TECHNICAL BULLETIN INDEX
Sorted by Bulletin Number

Tandy 2000 Orphans

DATE: December 8, 1983
 REVISION DATE: April 18, 1988
 BULLETIN NO.: 2000:1
 PRODUCT: 26-5140 High Resolution Graphics PCB
 SUBASSEMBLY: AX-9450 Graphics PCB
 SUBASSEMBLY REVISION: Rev. PP2

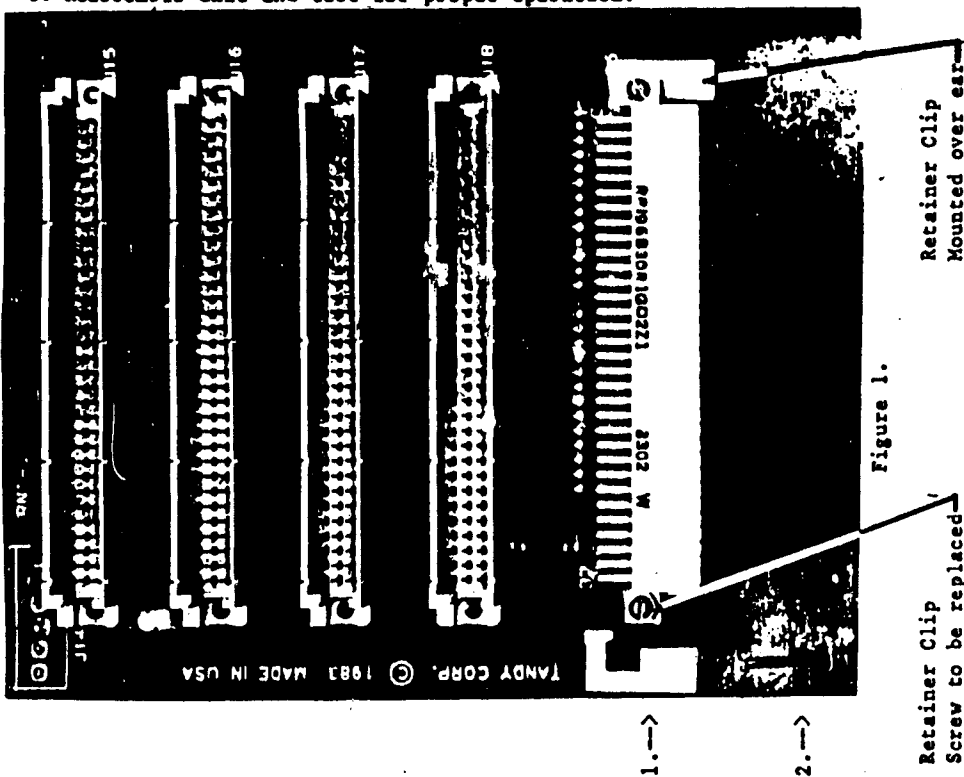
Note: If the screws and nuts securing (P6) to the motherboard are soldered together omit step 3.

3. (Refer to figure 1.) Remove screws and nuts holding (P6)(96-pin connector) to the motherboard. Replace the original screws with the #4 x 1/4" screws and the #6 lock washers. These are used to hold the retainer clips tightly in place.

4. (Refer to figure 1.) Place the retainer clips over the screw ears of the connector (P6) behind #6 lock washer if used.

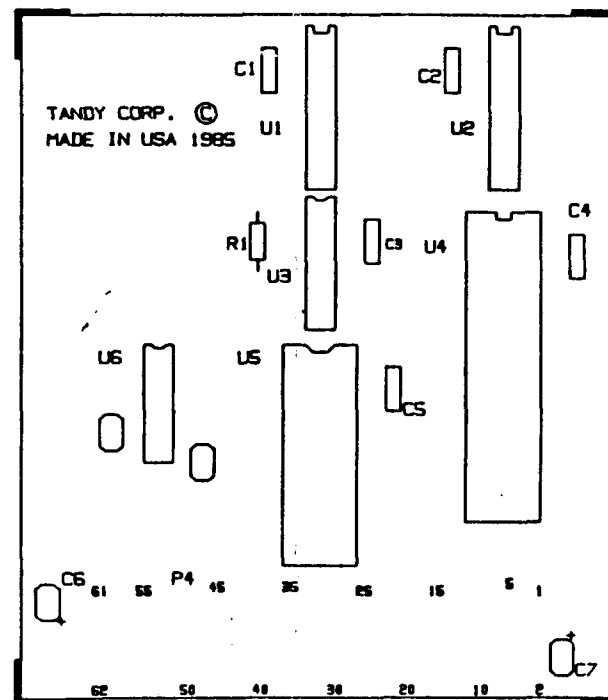
9. Carefully disconnect the connections to the main logic PCB and remove the PCB and metal chassis.
10. There are two case standoffs underneath the main logic PCB. To allow room for the coprocessor PCB the standoff located near the motherboard must be trimmed down, using a large pair of wire cutters or tin snips, as close to the screw as possible.

* DO NOT FORCE THE BOARD. *
 * *
 * If any force is required to seat the boards *
 * the standoff has not been cut short enough. *
 * Note, a shorter screw may be required to *
 * avoid shorting the coprocessor PCB. *

Figure 1

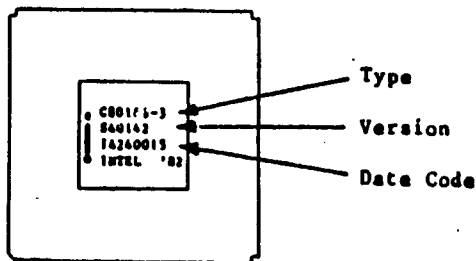
There are two items to check, clock speed and version number. If either one, or both of these numbers are incorrect the chip must be replaced. Figure 1 shows a typical 80186 CPU chip.

Note the type number may be prefixed with either a "C" or an "R". Either of these is correct. This prefix is Intel's chip package code.

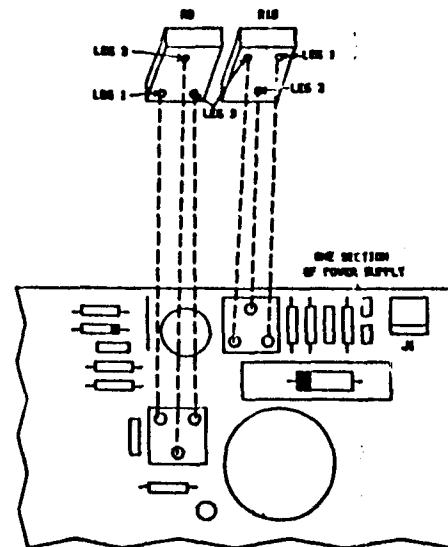
The power supply for the Tandy 2000 has two potentiometers. One to adjust the +5 volts (R10) and another to adjust the +12 volts (R8). During operation it has been found that these potentiometers will change value. This could cause the voltage to increase which in turn causes the power supply to go into current limiting mode; shutting itself down and rebooting the computer.

To eliminate this voltage fluctuation, the potentiometers must be replaced with fixed resistors. Two items must be noted here. First, the required resistance may not be a standard value resistor which will indicate that a series and/or parallel resistor combination must be used. Secondly, the +5 volt potentiometer will require two resistors (or combinations) where as the +12 volt will only require one resistor (or combination). This is because the +12 volt potentiometer's slide arm is connected to one of its fixed legs.

1. Gain access to the power supply's potentiometers by removing the top case of the Tandy 2000 and the top metal shield of the power supply.
2. With ALL of the customers expansion boards installed, turn the unit on and measure the +5 and +12 volt supplies and adjust them if necessary.

3. Turn the unit off and remove the power supply PCB.
4. Referring to the figure below remove R10 (+5 volt), observing the leg orientation. With an OHM meter measure the resistance between Leg 1 and Leg 2. This is the first fixed resistor value. Measure the resistance between Leg 3 and Leg 2. This is the second fixed resistor value.

6. Remove R8 (+12 volt), observing the leg orientation. The power supply PCB has Leg 3 connected to Leg 2. For this reason only one fixed resistor is required. The value for this fixed resistor can be measured between Leg 1 and Leg 2.

+5 volt range = 5.00 to 5.25

+12 volt range = 11.75 to 12.25

ILLUSTRATIONS FOR MOD NUMBER 44

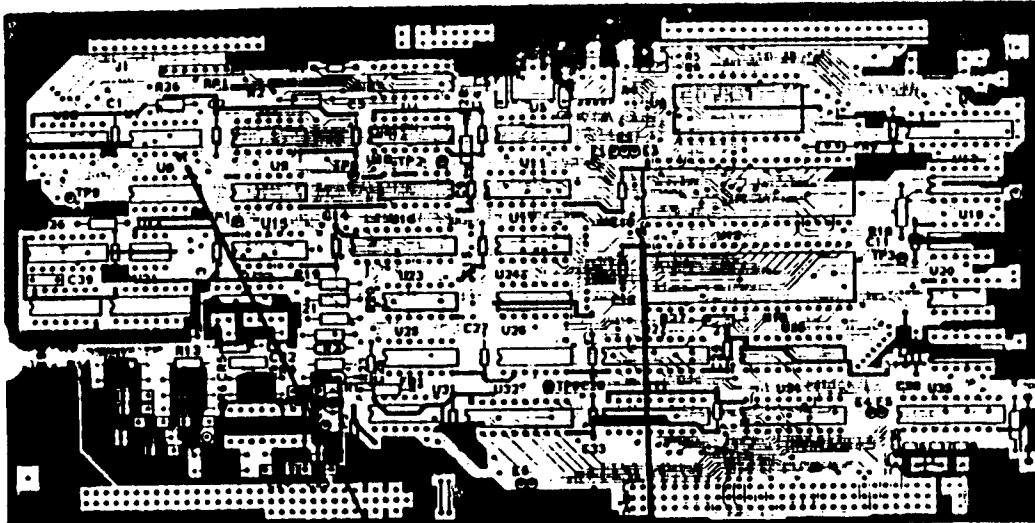
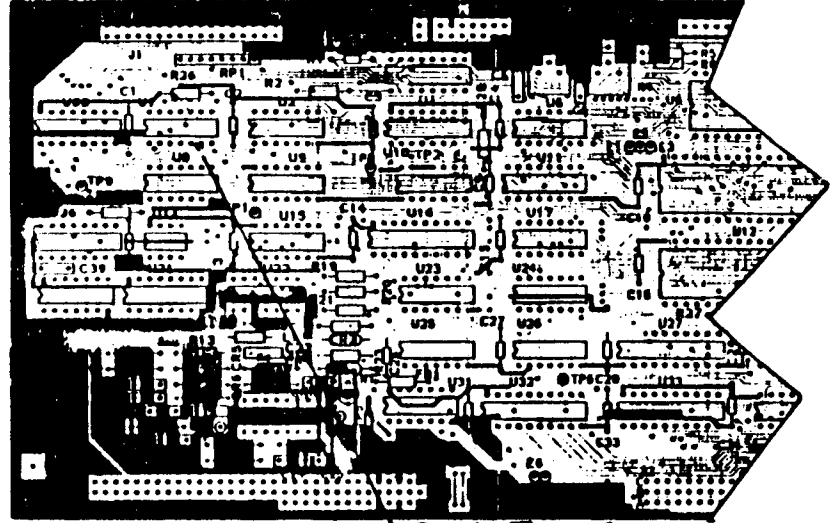
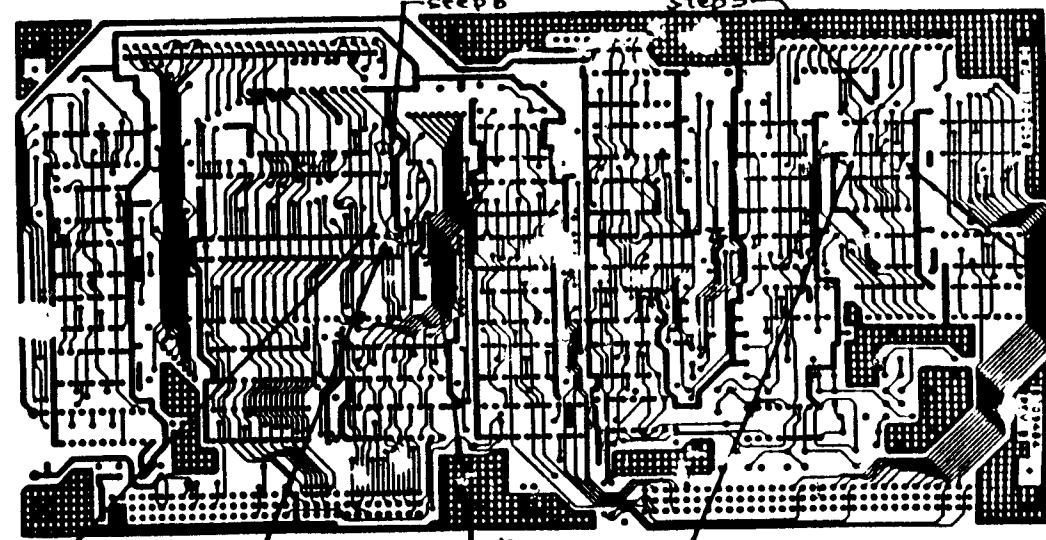
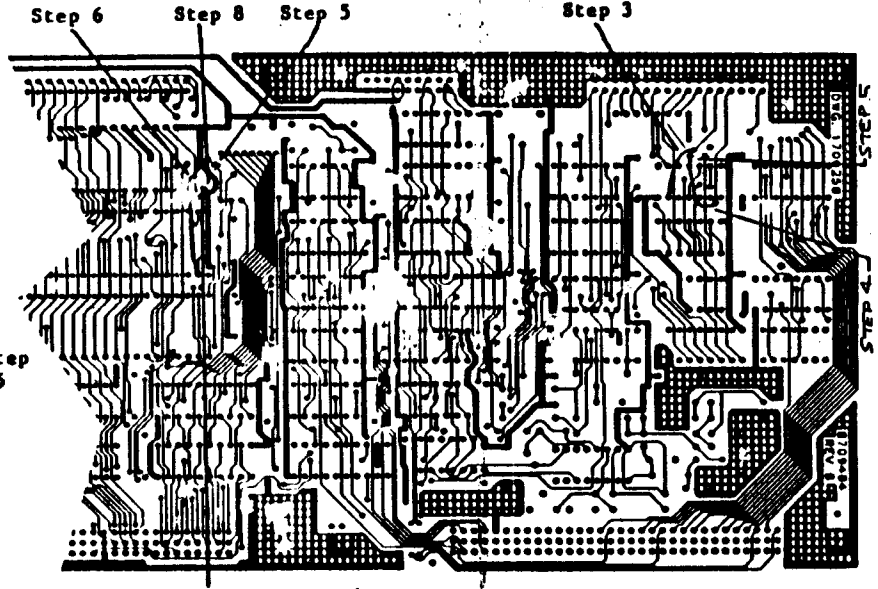
DISCUSSION: This bulletin outlines the original and enhanced procedure for changing the AX-9575 controller boards for use with one external secondary hard drive. For proper alignment of the controller board a 4MHZ square wave is fed into the data input of the WD-1100 to adjust the DLYDATA signal and to perform the preliminary adjustment of the DRUN signal. The original modification does not allow the 4MHZ signal to be fed into the WD1100 but uses the DRD2* signal from the hard drive for these adjustments. Computers requiring this modification should be modified using the enhanced procedure. Computers in for repair with the original modification should be converted to the enhanced modification, for proper alignment of the Hard Drive Controller.

ON THE COMPONENT SIDE REFER TO FIGURE 3:

ON THE SOLDER SIDE REFER TO FIGURE 4:

2. Cut the trace going to U1 pin 11 at pin 11.
3. Jumper U1 pin 6 to the feedthrough that used to go between U1 pin 11 and J1 pin 26.
4. Jumper U1 pin 11 to the feedthrough between pins 1 and 2 of U1.
5. Cut the trace going from E3 to the feedthrough.
6. Jumper the feedthrough in step 5 to U12 pin 2.
7. Cut the trace from U12 pin 2 at the feedthrough.
8. Jumper the feedthrough in step 7 to E3 staking pin.

ON THE COMPONENT SIDE REFER TO FIGURE 1:

ON THE SOLDER SIDE REFER TO FIGURE 2:

1. Remove the jumper from U12 pin 1 to the feedthrough. Refer to Step 7 of the original procedure and drawing.
2. Remove the jumper from U12 pin 2 to the feedthrough. Refer to Step 8 of the original procedure and drawing.
3. Jumper U12 pin 1 to the E2 staking pin. This remakes the trace cut in Step 1 of the original procedure. Refer to Step 9 of the drawing.
4. Refer to the enhanced modification on Page 1 of 6 and perform steps 5, 6, and 8.
